INTER-OFFICE MEMORANDUM

DATE: April 17, 2024

SUBJECT: Chapter 5 §5-58 of the City of Newton Ordinances, request for review for site and building construction at 225 Nevada Street for the Horace Mann Elementary School

B. Adequacy of the methods for regulating surface water drainage

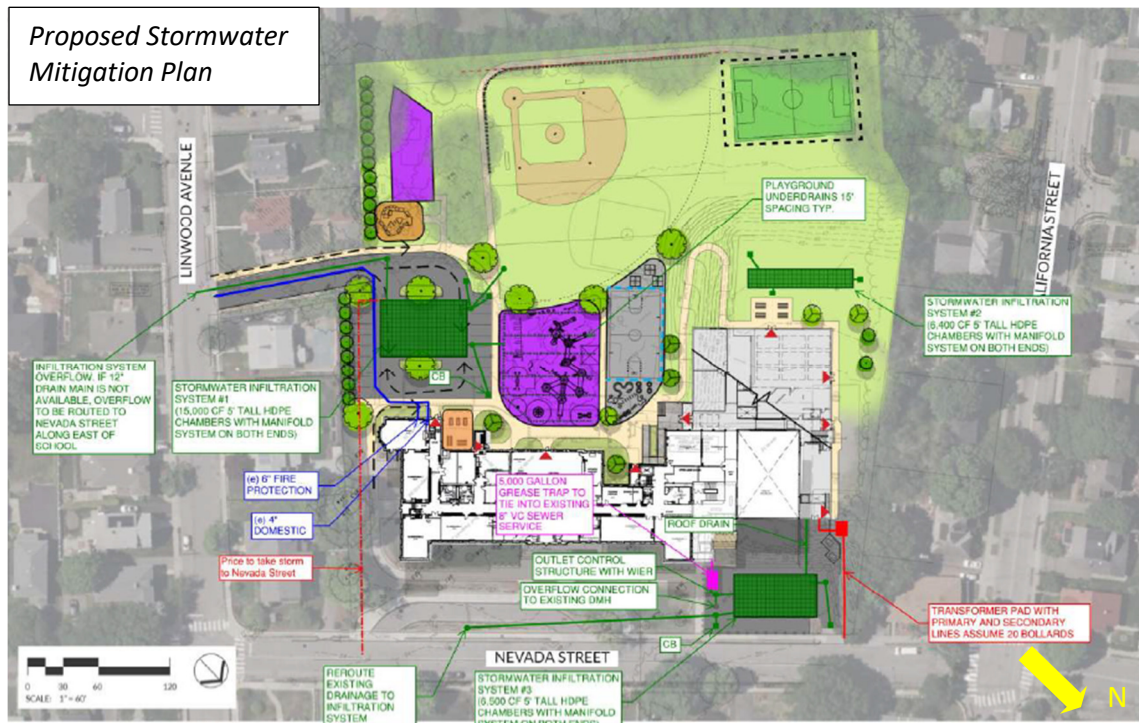
The proposal increases the total impervious area by 30,231 square feet to 109,118 square feet with expansion of the building footprint, parking spaces and recreational areas such as the playground and basketball court. The plan to offset these additions includes three improved catch basin and infiltration systems, phosphorus filtration system, and a rain garden. The site has undergone hydrological and geotechnical testing and modeling, designed to measure the current water table and the proposed system’s ability to handle stormwater. With the proposed increase to impervious surface and updated stormwater system, the provided modeling for the stormwater system demonstrates an equal or improved performance for all three improved catchment systems under 2-, 10-, 25-, and 100-year storms.

- D. Avoidance of topographic changes; tree and soil removal shall be minimized.

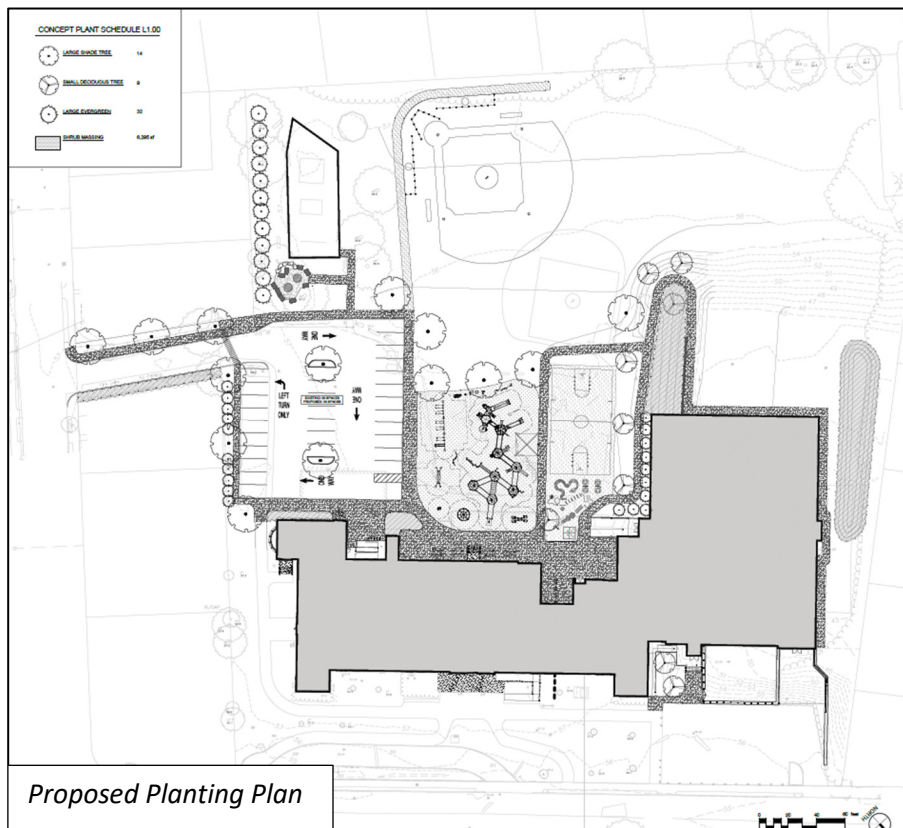
The location of the additions to the building avoids major topographic changes as the proposed building additions will mainly occur on flat terrain to the west of the existing building. Loam will be removed per the below site preparation plan, however this will not result in any significant change to the quality or quantity of soil on site and should have minimal ecological impact. As the proposed Tree Removal Plan and Planting Plan below demonstrate, there will be a net gain of trees in caliper inches. Six trees, totaling 68 caliper inches of deciduous trees and 16 caliper inches of evergreen trees, are proposed to be removed. In place of those trees, a total of 55 trees, 69 caliper inches of deciduous trees and 48 caliper inches of evergreen trees will be added.
